**ITEM 5. DEVELOPMENT APPLICATION: 58-60 MARTIN PLACE AND 3D MARTIN PLACE AND 197 MACQUARIE STREET SYDNEY****FILE NO: D/2015/509****DEVELOPMENT APPLICATION NO: D/2015/509****SUMMARY**

The subject application (D/2015/509) is supported and recommended for a deferred commencement approval to enable the Applicant to provide a detailed demolition works methodology statement.

**Figure 21:** Eastern (Macquarie Street) elevation signage zone

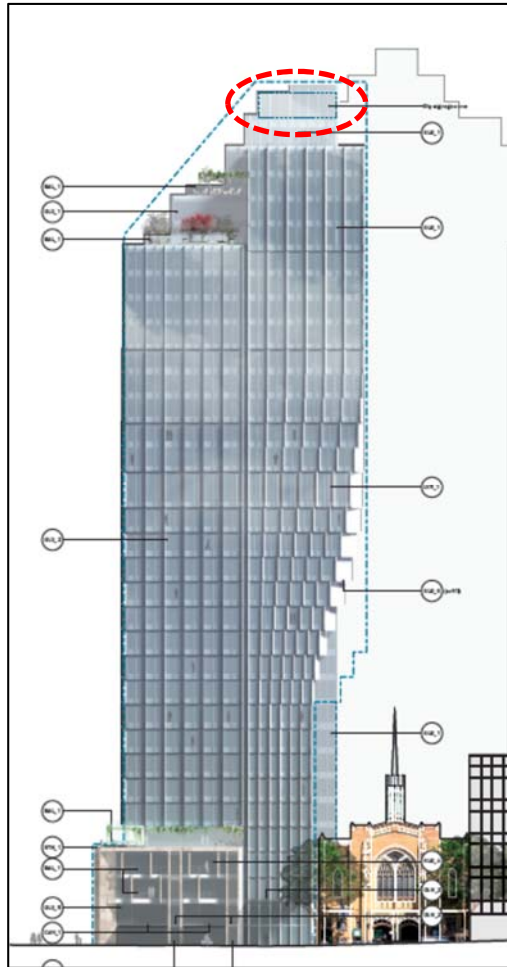
- (d) No consent is given or implied to the four building identification signage zones/building name signs illustrated on the plans (notated as 'sky signage zone').
- (e) Amended plans shall be submitted reducing the number of signage zones/building name signs to a maximum of two elevations. As amended, the development may have a maximum of two (2) building identification/building name signs at the roof-top parapet level of the building.

**Figure 25:** Section drawing illustrating extent of cantilever above the church

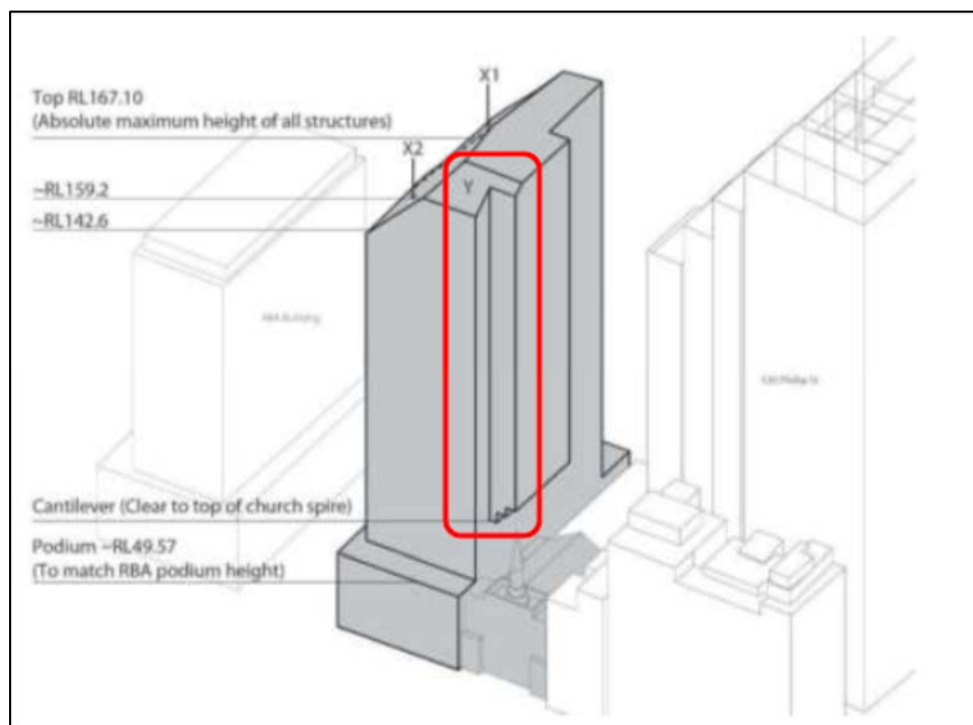
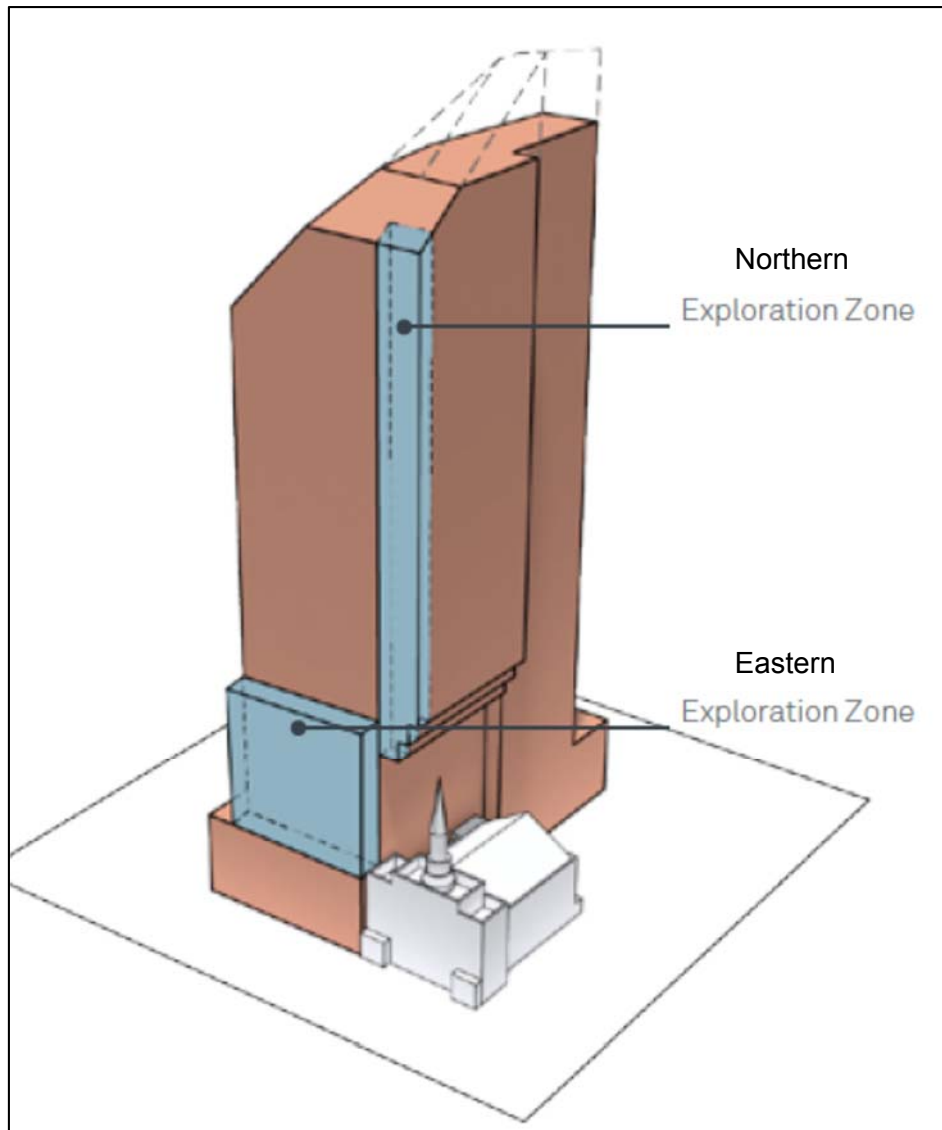
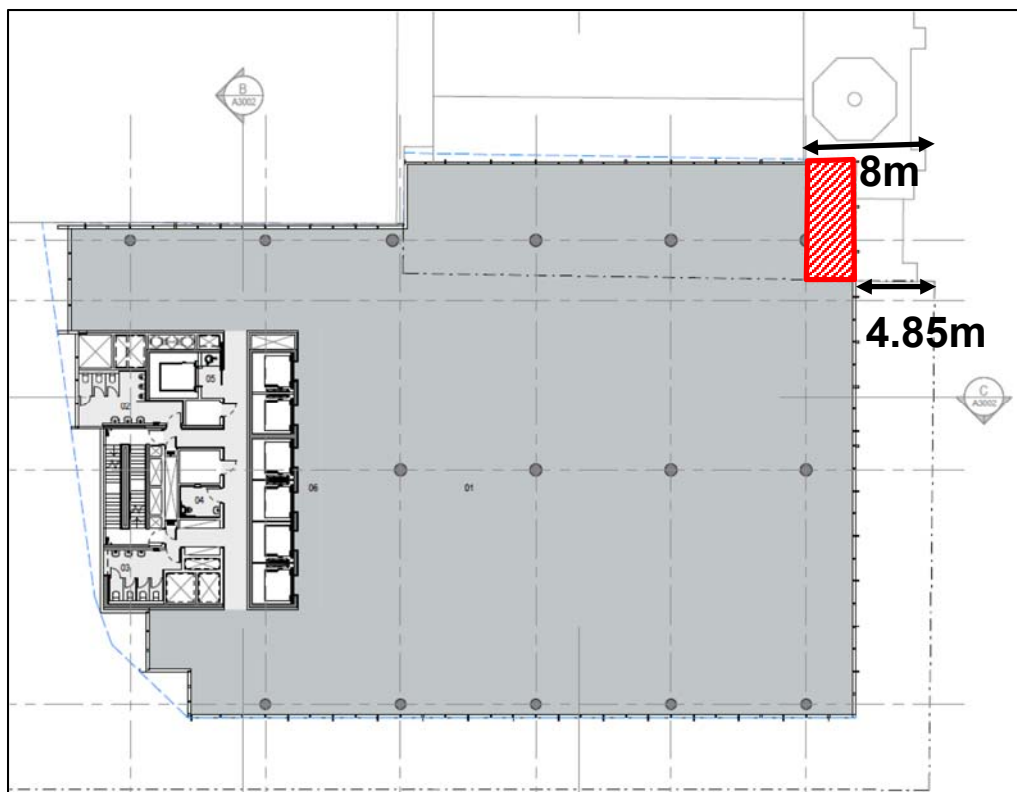
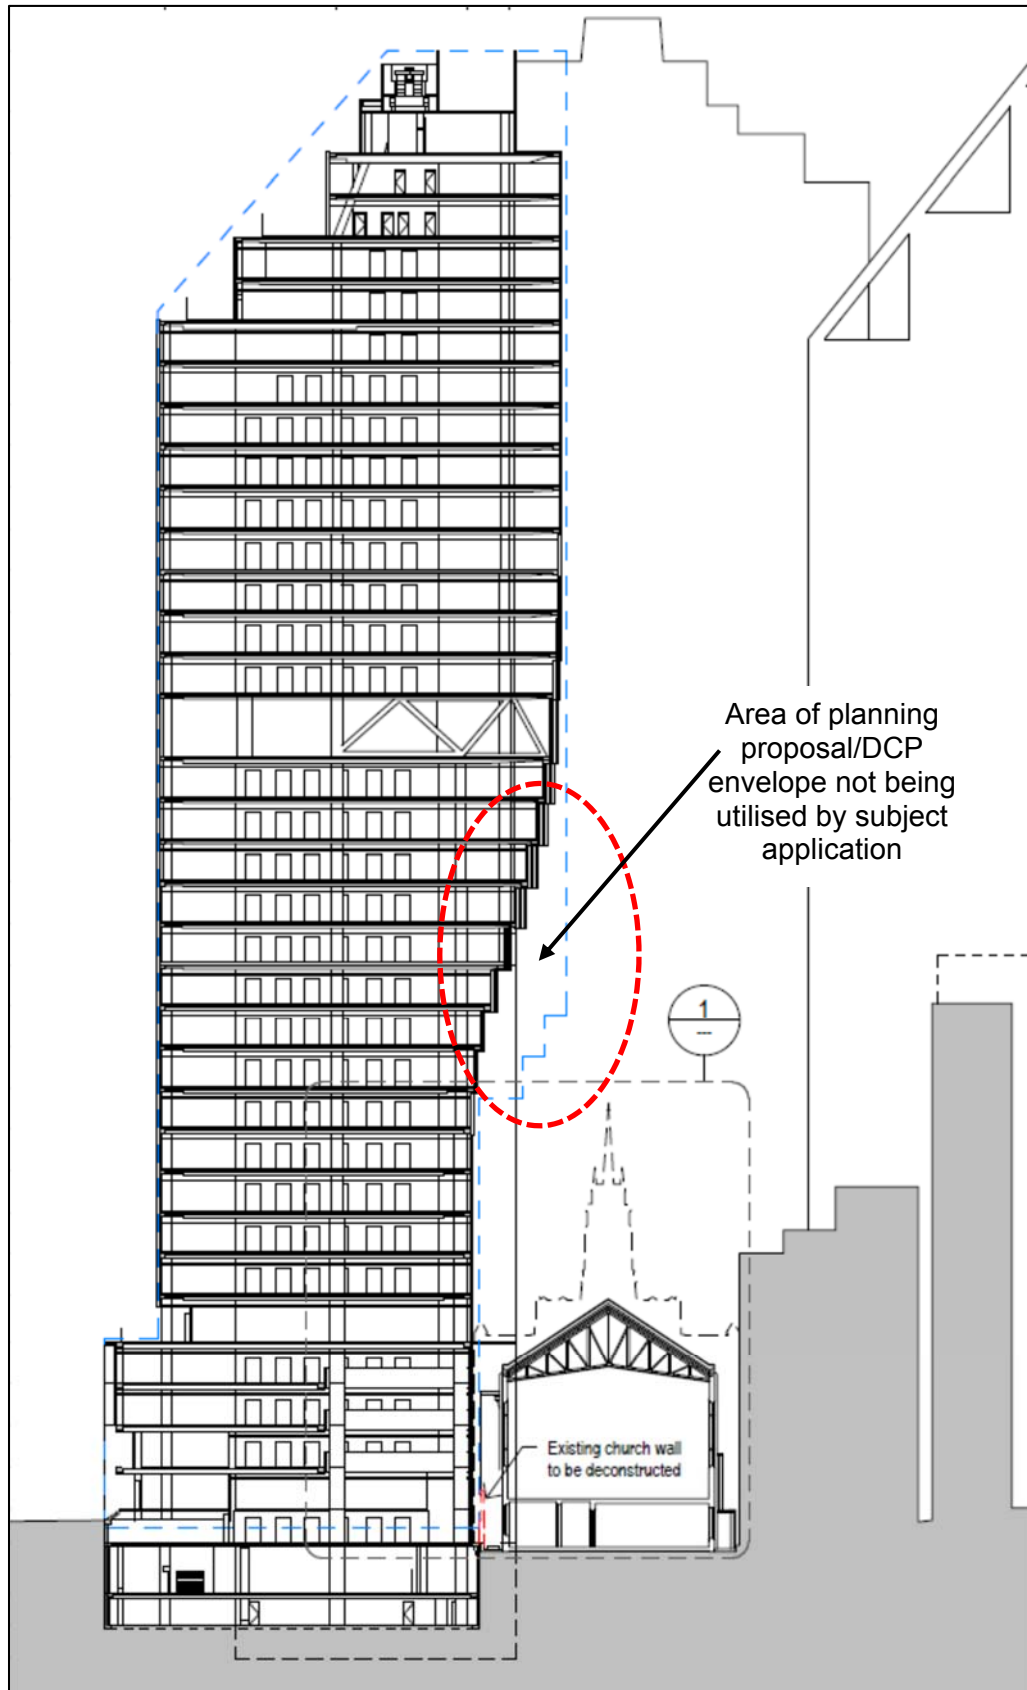
71. The proposed variation to the DCP envelope for this cantilevered element occurs on Level 11 and above of the tower. The extent of projection into this zone varies from approximately 450mm (on Level 11) to 8 metres (on Levels 22 and above) based on the stepped form of the design (refer to **Figure 25**, below).

- (c) as illustrated in **Figure 25**, above, the proposed development does not seek to fill the entire DCP building envelope. Whilst the scheme does seek to bring the cantilever closer to Macquarie Street, it is also proposed that the height of the cantilever element be higher than anticipated in the DCP envelope. This would increase the separation between the tower and spire of St Stephen's Church (noting that the full expanse of the cantilever does not occur until Level 21 rather than at Level 12 as permitted in the DCP envelope);

**Figure 30:** Design refinement is required to improved views from the 'civic room' out to Macquarie Street

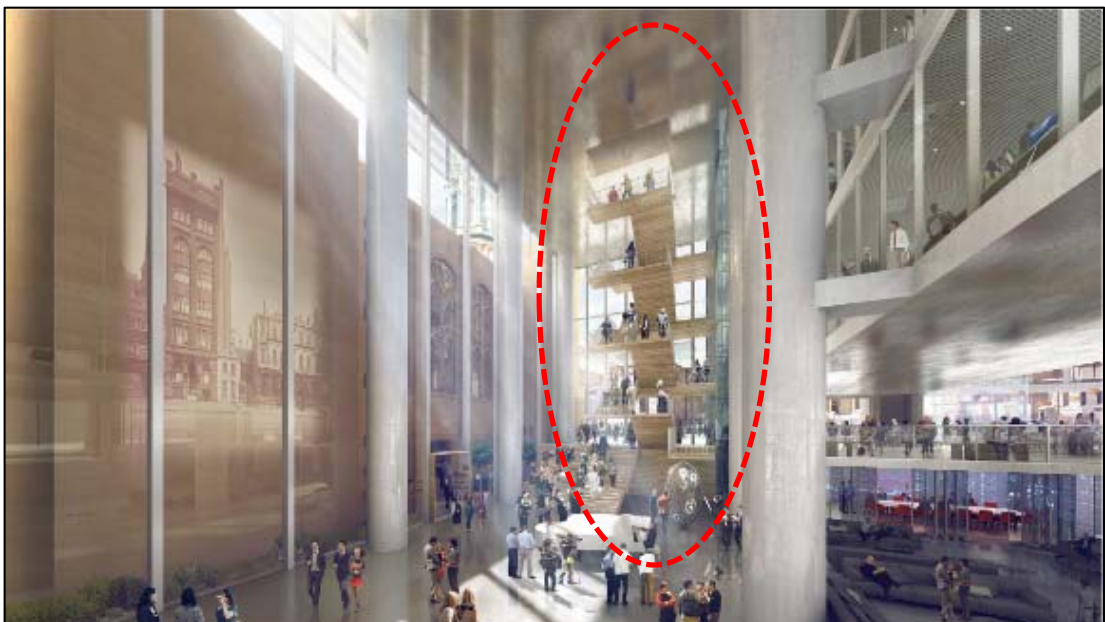
- (b) Amended plans shall be submitted to modify the design and materiality of the internal podium stair (connecting the Upper Ground floor to Level 4) in order to improve views from the Lower Ground Level out to Macquarie Street.

76. Concern has been raised during the assessment from both a heritage and urban design perspective that the current siting of the internal podium stairs should be further refined (refer to **Figure 30**, below). A design modification condition has been recommended to require that the location and design of this internal stair be amended to improve visual permeability through to Macquarie Street. As the lower ground floor of the building is to be publicly accessible and used for functions, it is considered that the overall design would benefit from greater visual connectivity.

**Figure 31:** The proposed plant room louvers on the Macquarie Street elevation of the development

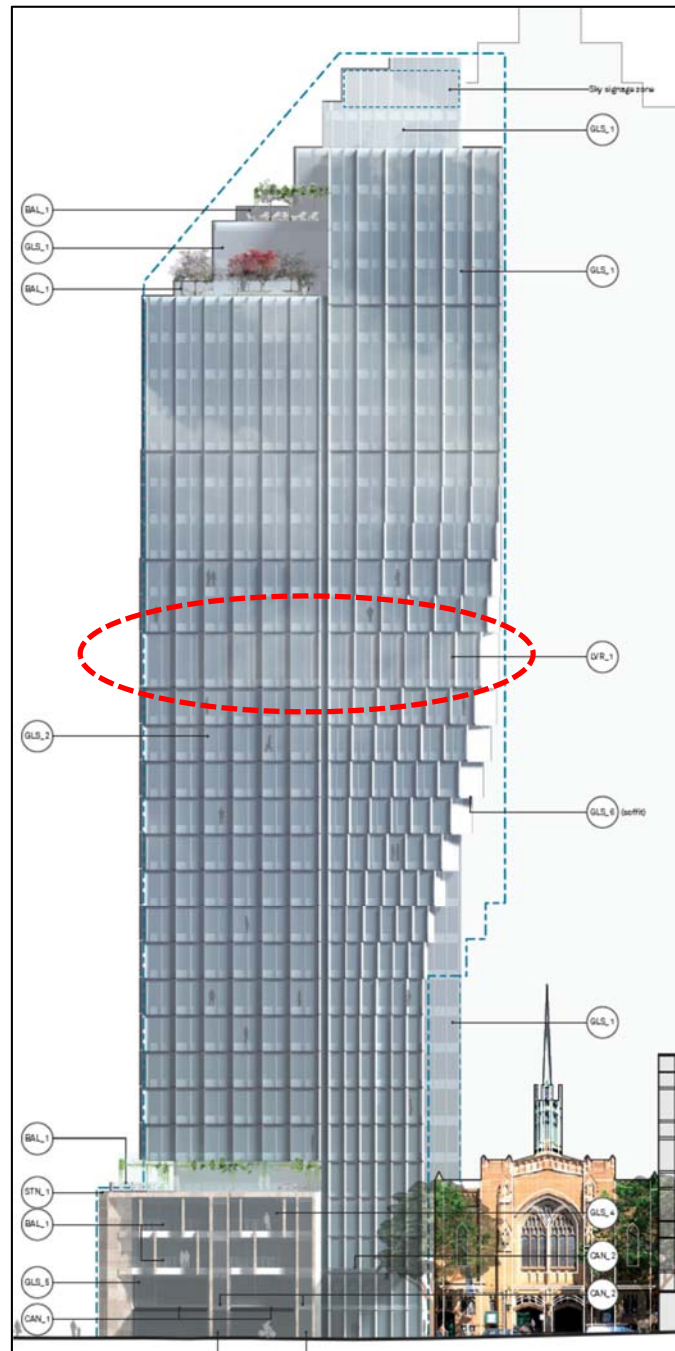
- (c) Amended plans and further documentation shall be submitted to minimise the visual disruption and break to the facade expression resulting from the Level 18 plant room. Further design refinement should be undertaken to consider the proportioning, materials and openings at this level of the building to ensure the continuity in the facade treatment.

77. The Design Advisory Panel raised concern regarding the external facade treatment of the mid-rise plant room (located at approximately level 18 of the development). It was noted that in its current form, that the materiality and expression is considered to be disrupting the continuity and language of the facades (particularly on the eastern and southern elevations). The current design is considered to be cutting the facade in half. It is recommended that further design refinement be undertaken to minimise the visual disruption of the plant and its air intake in the overall presentation of the building.
